## 11 27 24 - ADDENDUM 04 [FINAL]

### CHANGES TO THE PROJECT MANUAL

# NCSU BROOKS HALL RENOVATIONS - PHASE I

NCSU #20222002  
SC0#22-25338-02A

A0.1

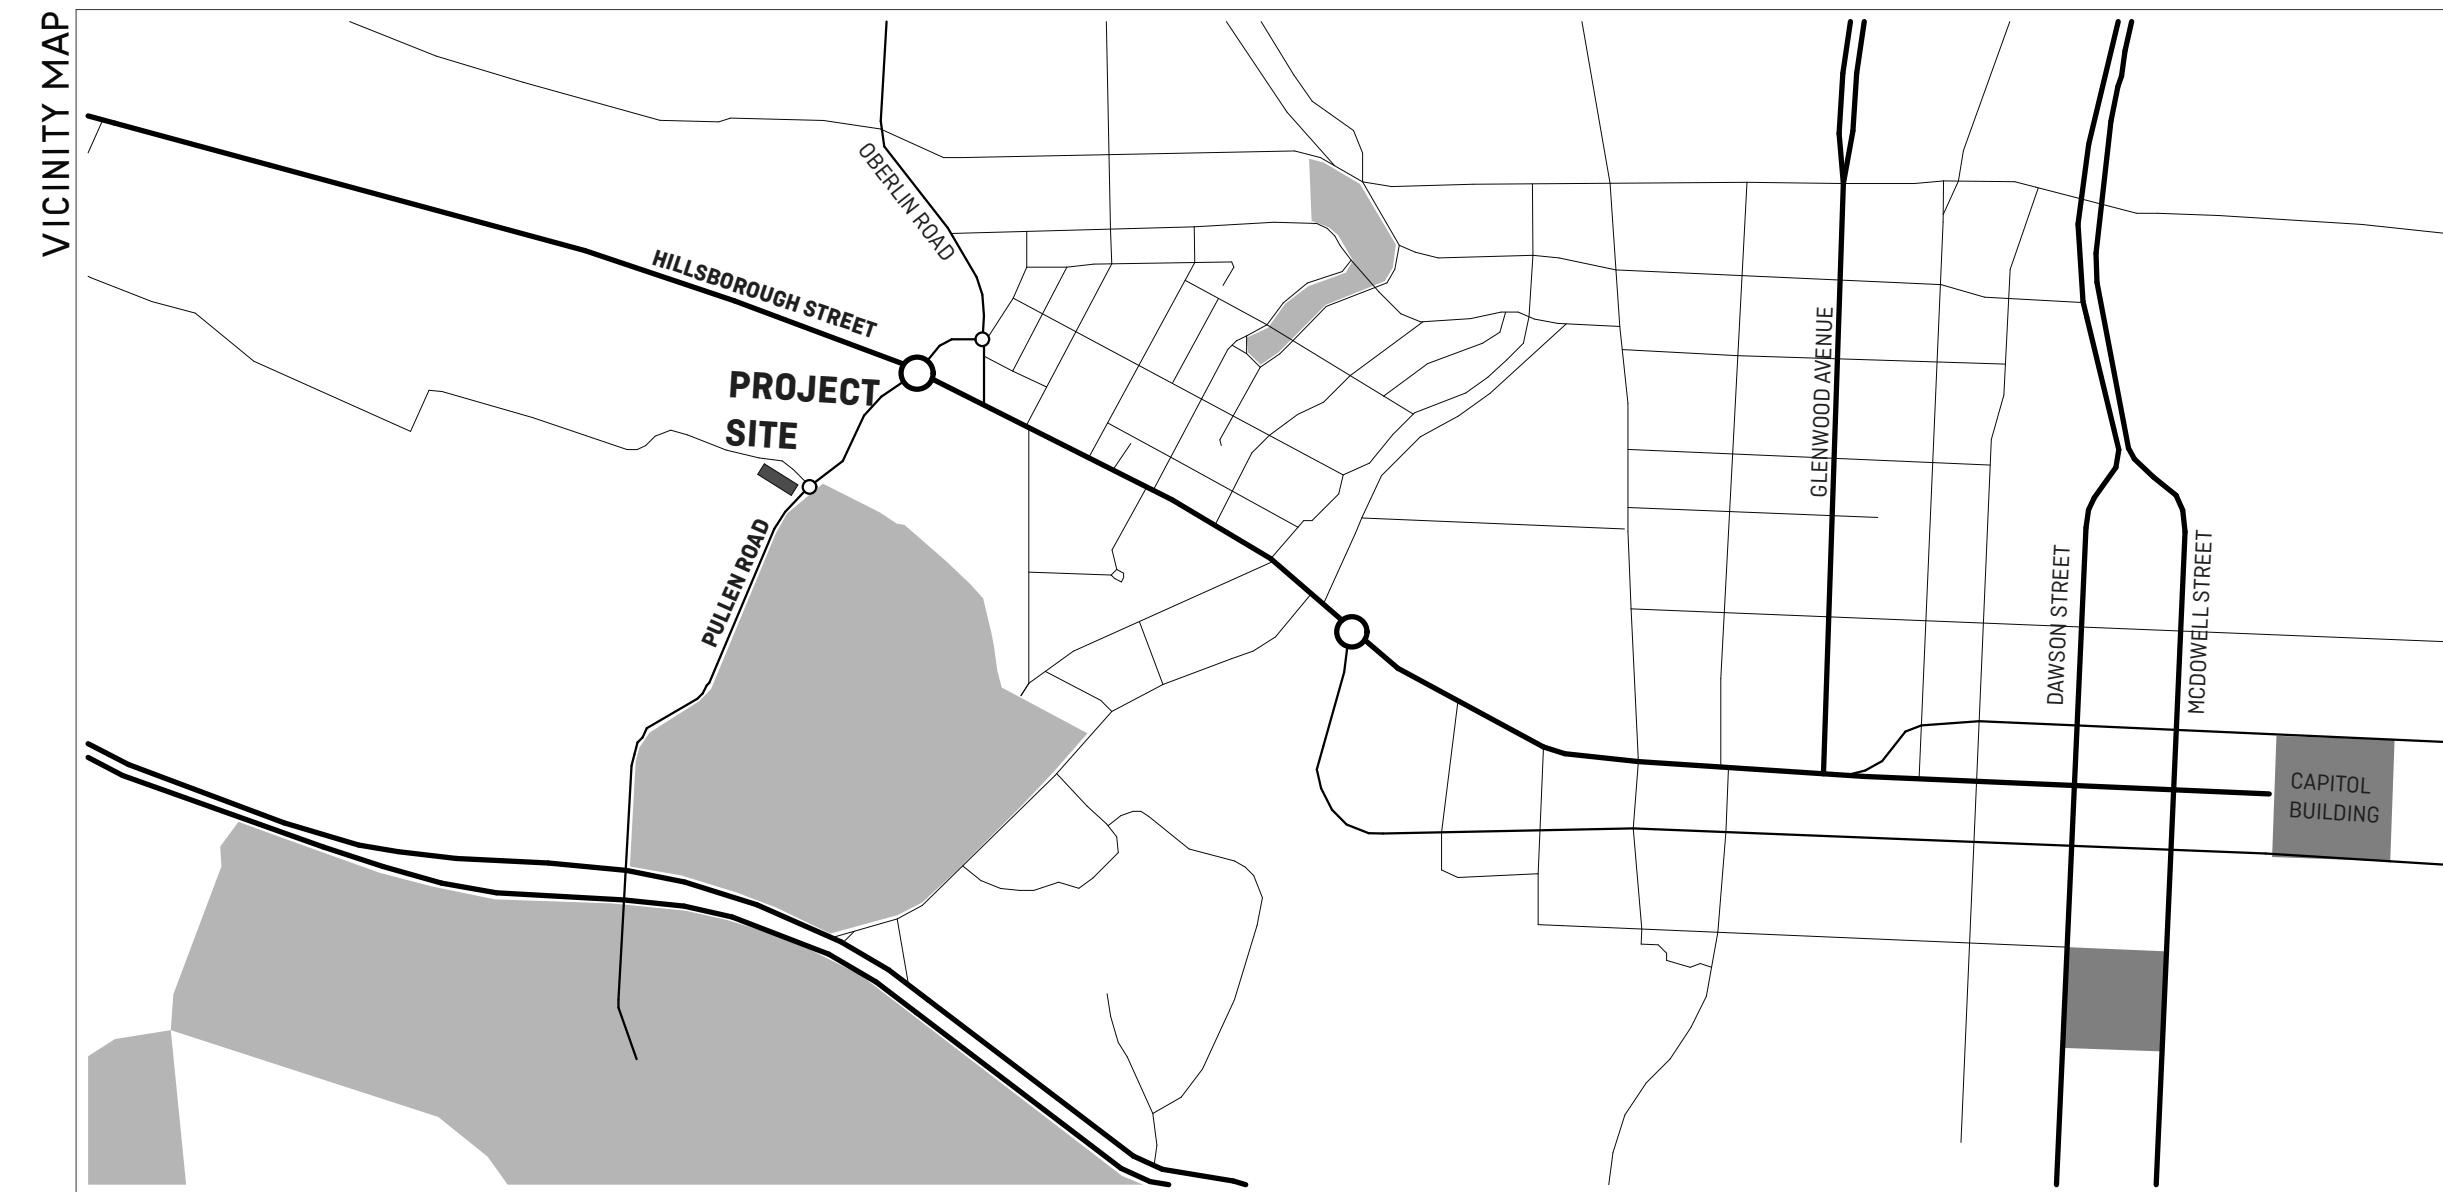
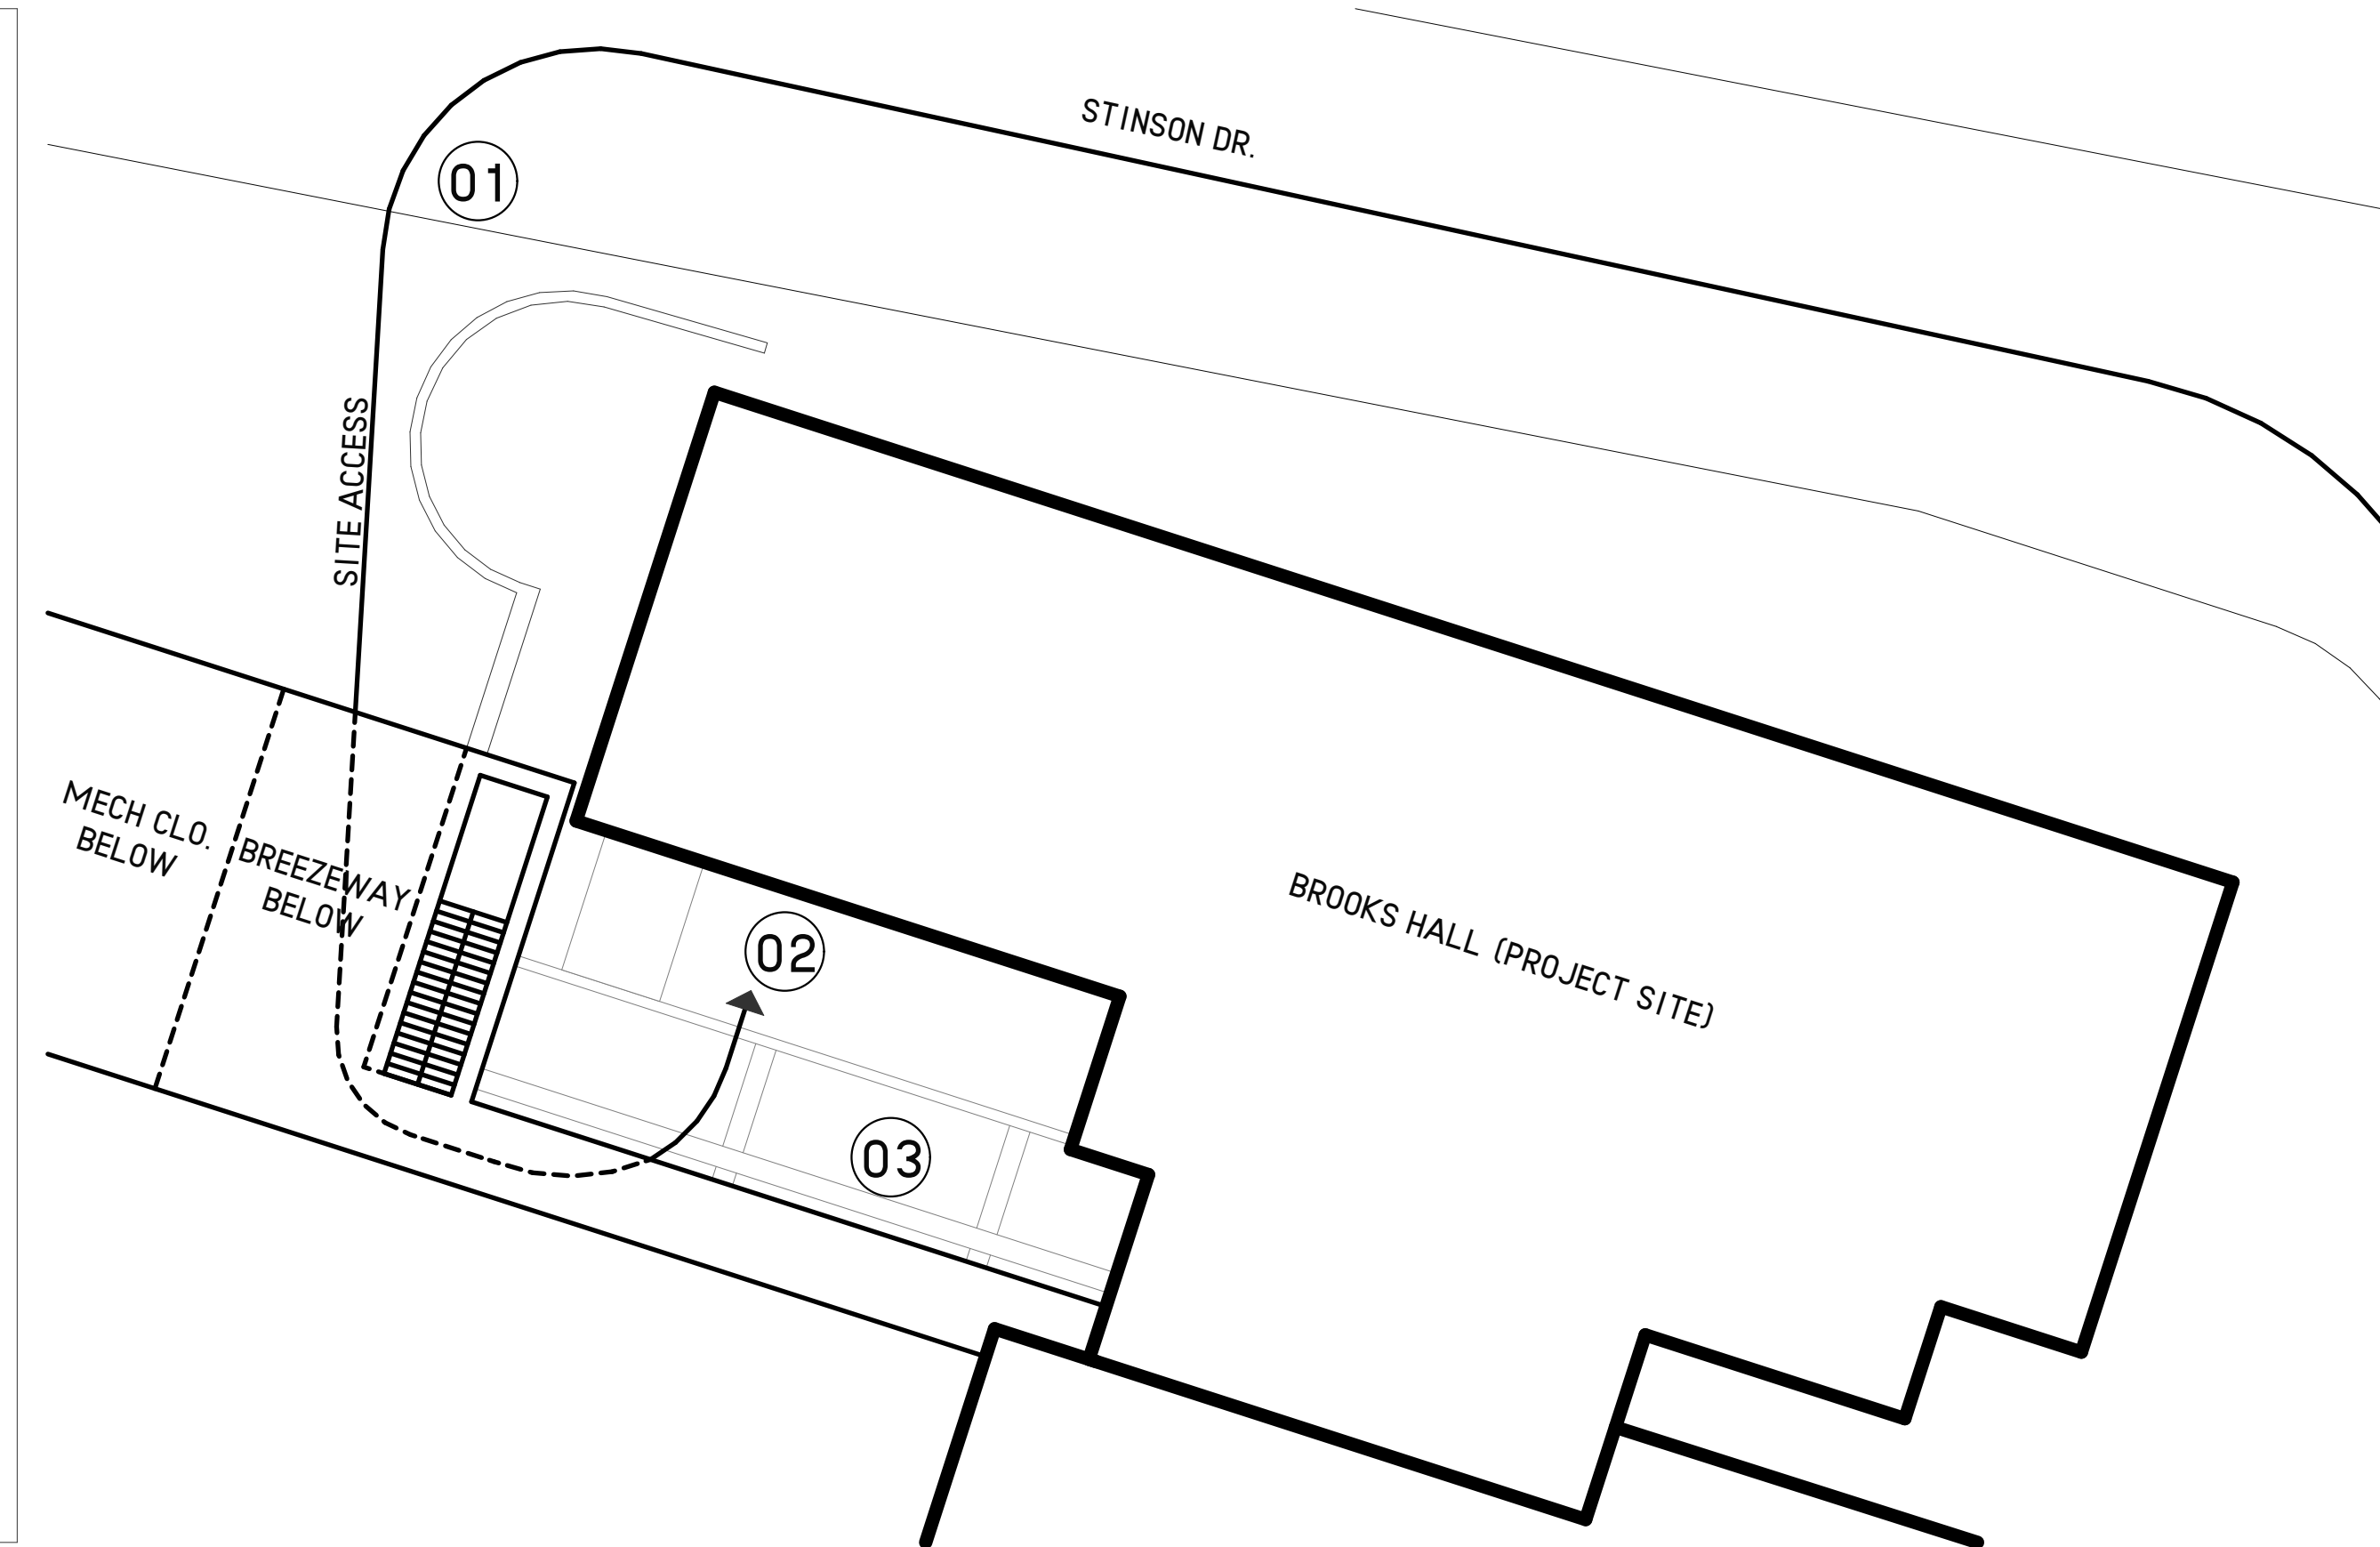
- Revised A0.1 Cover Sheet. Adds M1 and M2 preferred brand alternates per question below.

A1	ADD	COFFEE MILLWORK BUILDOUT
A2	ADD	SOUTH WALL PLAZA ALLOWANCE
A3	ADD	INTERIOR STOREFRONT IN FLEXIBLE RESEARCH OFFICE
A4	ADD	OPERABLE PARTITION WALLS - SUPPORTS ARE BASE BID
A5	ADD	LOWER BREEZEWAY PRESENTATION WALL AND CEILING - REF PARTITION SCHEDULE FOR DETAILS
A6	ADD	OWNER PREFERRED DOOR HARDWARE
A7	ADD	OFFICE MILLWORK BUILDOUT
A8	ADD	K12 MILLWORK BUILDOUT
M1	ADD	ALL CONTROLS TO BE SCHNEIDER ELECTRIC - REF 230900.
M2	ADD	ALL CONTROLS TO BE JOHNSON CONTROLS - REF 230900.
